NORTHERN WOLVES
AIR CONDITIONING

Project: **Sunrise Rye Brook - Independent Living / Assisted Living**

Mechanical drawings dated: 07.15.2026 (GMP set)

Mechanical Value Engineering Proposals

M2023 AL 2nd floor - DOAS branches with FSD into each apartment

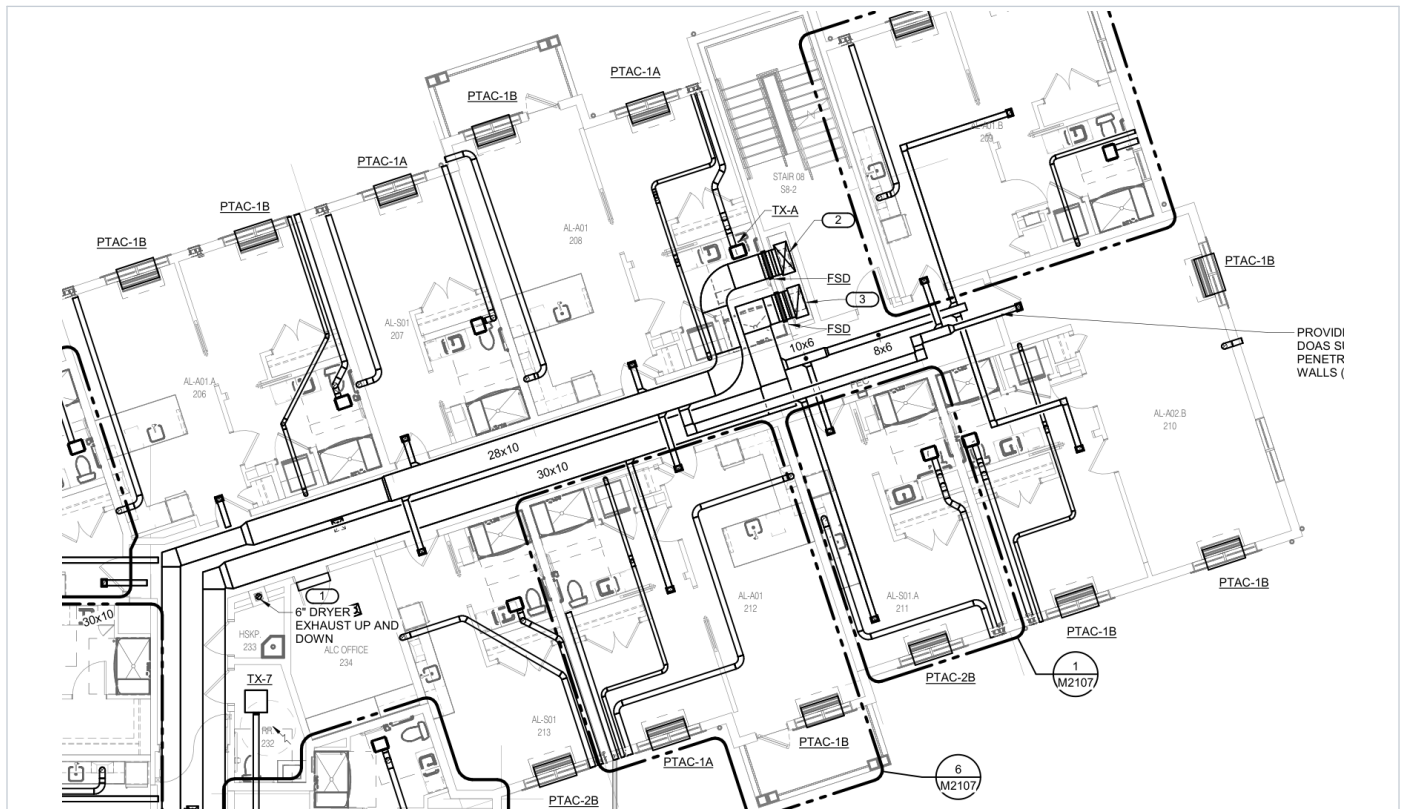
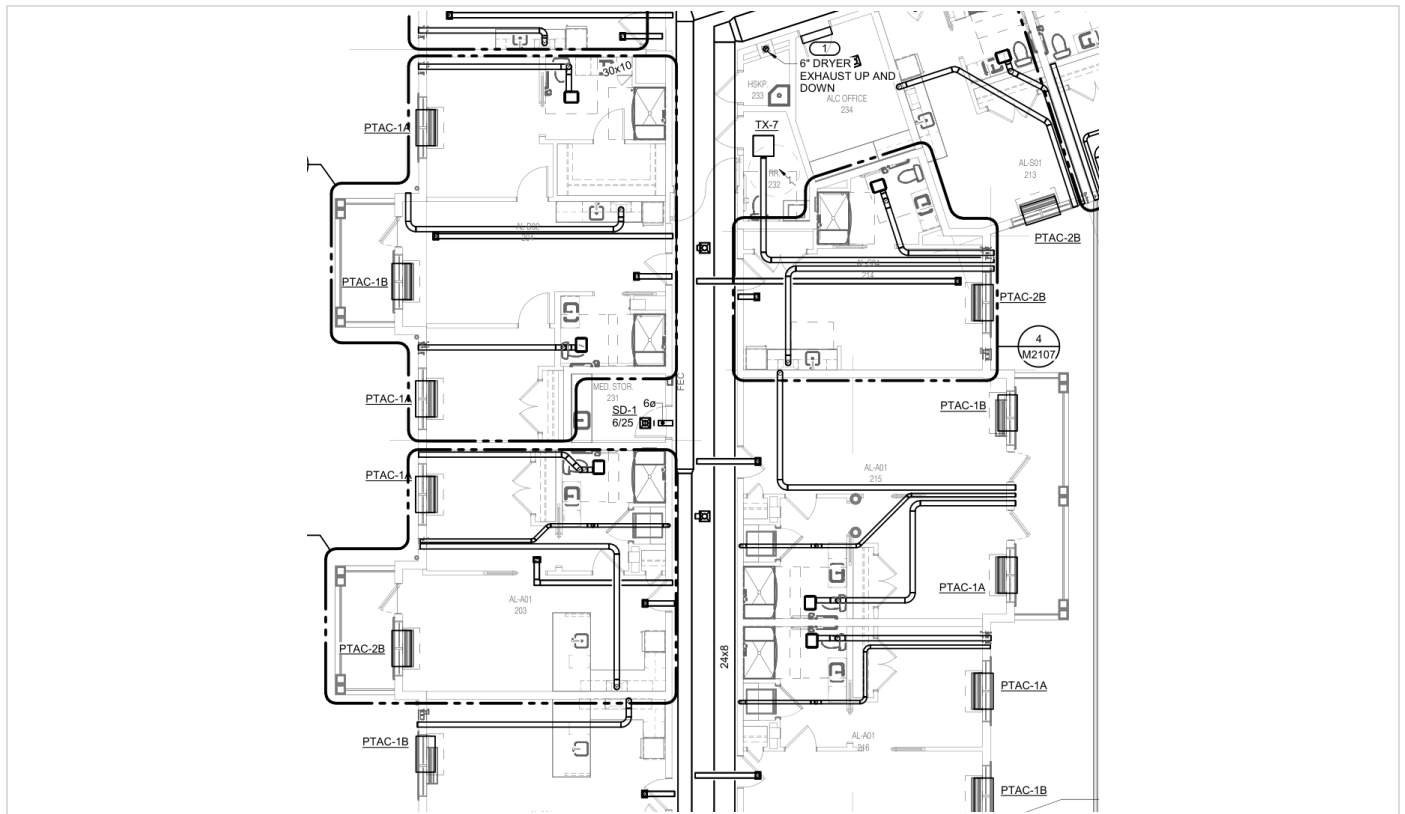
VE-07 Fire / smoke dampers at apartment duct branches

- Combination fire / smoke damper at every DOAS supply / return branch into each apartment (M2023 note: "provide fire/smoke damper at all DOAS supply/return penetrations through demising walls")
- Each damper needs power, fire alarm interface, access door in a finished ceiling and periodic testing

- Apartment branches (6x4 to 8x6) under 100 sq in, 26 ga steel, no openings into the corridor, above the ceiling, with 12" steel sleeve: no damper required at the corridor fire partition (IBC 717.5.4 exception); plain fire dampers as fallback
- Fire / smoke dampers kept at shafts and smoke barriers

M2108 AL unit plans - TX-A bath exhaust to exterior, SG-1 / RG-2 DOAS grilles

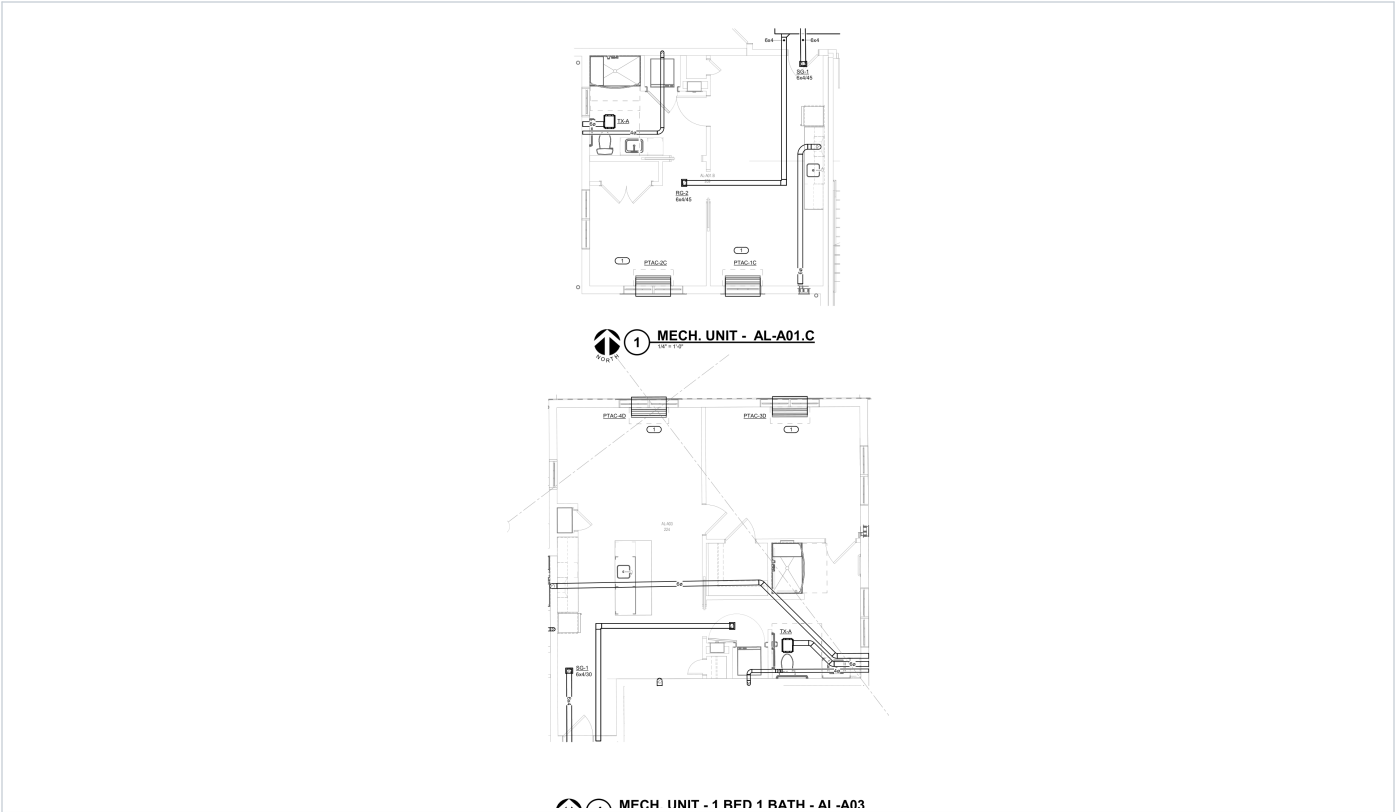
VE-08 Apartment bath exhaust to the DOAS energy recovery

- Each apartment bath has its own exhaust fan TX-A (75 CFM) ducted out the exterior wall
- DOAS return is taken from corridors and a few rooms; some AL unit types show a DOAS return grille RG-2, the floor plans connect the return trunk to only a few (to be clarified)

- Duct apartment bath exhaust to the DOAS exhaust trunk in the corridor (as on Sunrise of Northport); the DOAS energy wheel recovers the exhaust heat
- Delete the individual TX-A fans, wall caps and their electrical circuits; delete RG-2 in the units

M5000 - BMS-controlled hydronic terminals eliminated by VE-01 to VE-05

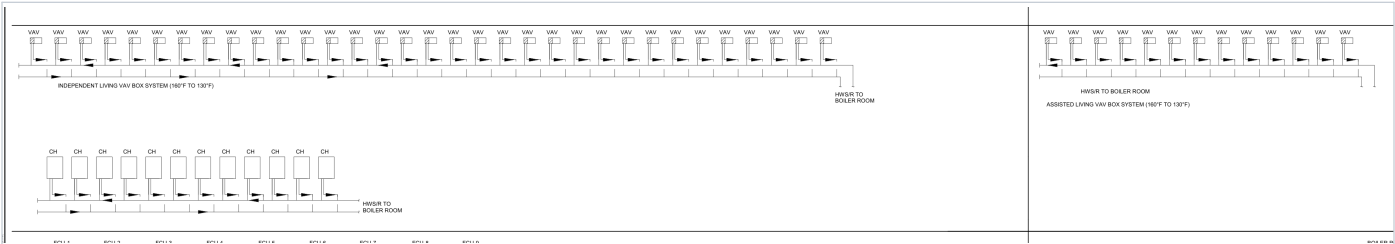
VE-09 Controls: standalone equipment controls in lieu of BMS

- Full BMS by the BMS contractor for boilers, pumps, heat exchangers, glycol, snow melt, VAV reheat, FCUs, cabinet heaters, rooftop units and DOAS

- With VE-01 to VE-06 the hydronic sequences (about 120 to 150 points) are gone
- Rooftop units and DOAS on their factory controls with network cards for future monitoring; heaters, mini-splits and PTACs on standalone thermostats (as on other Sunrise communities)
